| SUBMITTER No.  | <b>419</b>  | ISSUE REFERENCE:     | <b>4050 / 19012</b>  |
| SUBMITTER TYPE | Government  | TOR CATEGORY         | <b>EMP (Land)</b>  |
| NAME           | <b>DERM</b> | RELEVANT EIS SECTION | Chapter 7 – Environmental Management Plan: Mine, Section 7.8.18 Element 18 – Land Rehabilitation |

Figure 1. Mine Infrastructure Plan

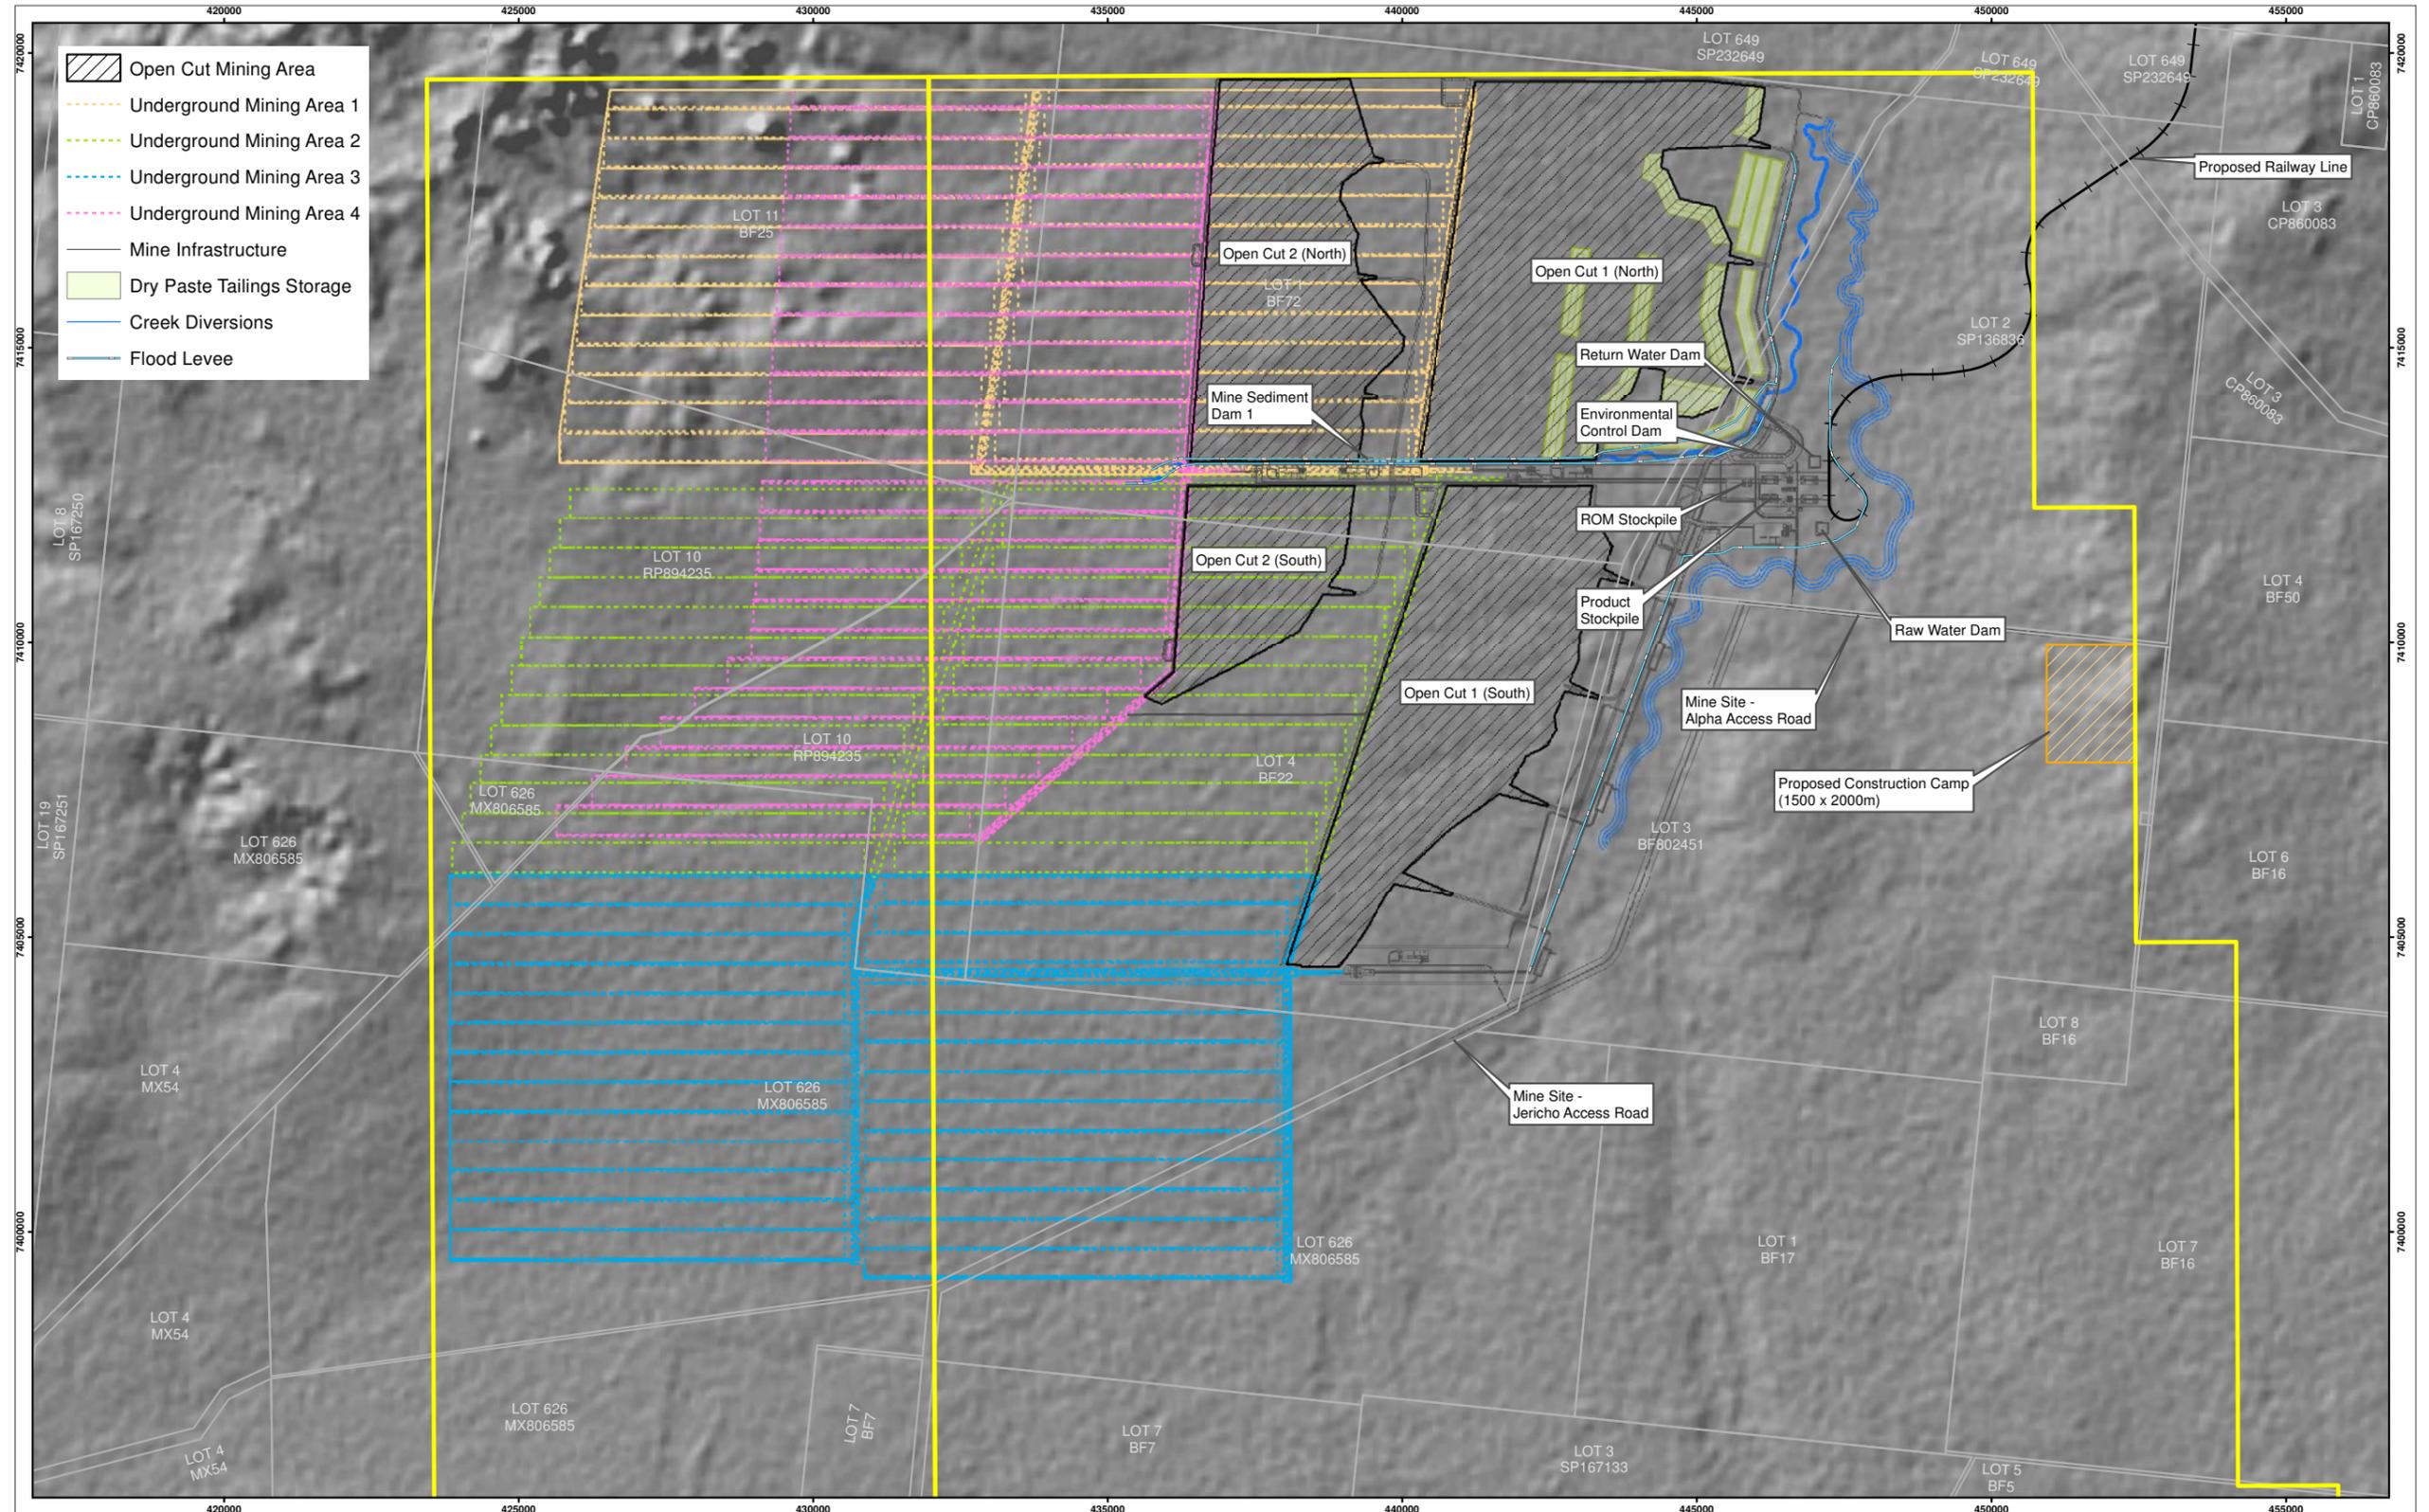
The EIS does not provide the necessary details on the proposed containment system proposals for the mine site. The EIS and EM plan should describe and identify on maps at suitable scale the location and form of all necessary mining infrastructure on the mine site.

The EIS and EM plan should detail, as a minimum:

1. The location and size open-cut pits, including proposed size and shape of final voids
2. The location and footprint of essential plant, including the coal preparation plant, stockpiles and loading facilities
3. The location and size of overburden dumps
4. A containment system for the management and permanent storage of tailings
5. A containment system for the management of runoff and seepage from overburden rock dumps
6. A site water management system for the management of runoff from around the site and the surrounding catchments that would normally pass through the site, and
7. Any associated diversion channels, levees and dams required to control and store contaminants generated by the mining activities or to protect the mine workings from flooding.

A revised mine site infrastructure layout has been prepared to detail these features (see Figure 1).

1. Figure 1 shows the location, relative size and shape of the final voids. The total area of footprint for the open-cut mines is 7437 ha. The individual size for each open-cut mine is:
  - Open-cut No. 1 North: 2803.03ha
  - Open-cut No. 1 South: 2077.41ha
  - Open-cut No. 2 North: 1776.20ha, and
  - Open-cut No. 2 South: 780.22ha;

2. The location and footprint of essential plant is shown on Figure 1. The footprint area for the CHPP, stockpiles and loading facilities is 120ha.

3. The location and size of the overburden encapsulation areas is shown on Figure 1. The collective size of these areas is 1816ha.
4. Proposed containment systems for the management and permanent storage of tailings and rejects are detailed in the *Tailings Storage Facility Update* report in the *Appendices – Volume 2* of this SEIS. The tailings will be dewatered using filter press conveyors and the tailings paste and rejects will be trucked to disposal cells constructed initially within the box-cut spoil piles and later within the in-pit spoil piles.
